4L60 (700-R4)

MODIFICATION

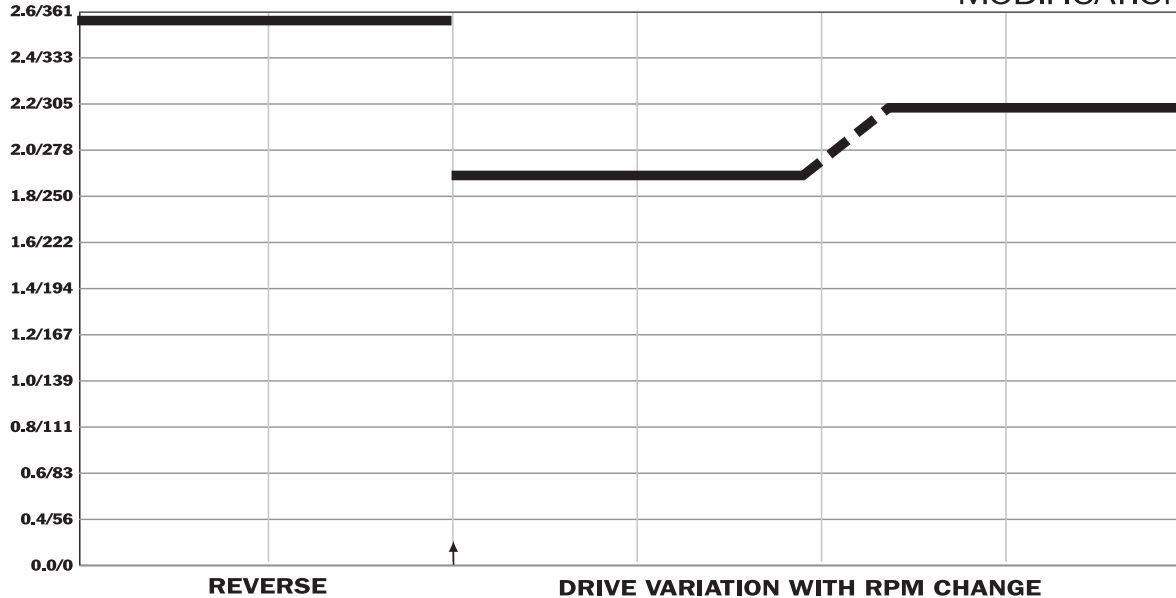
Condition: Two flats on pressure regulator valve to feed converter.

Notes: In this modification, high flow influences high pressure.
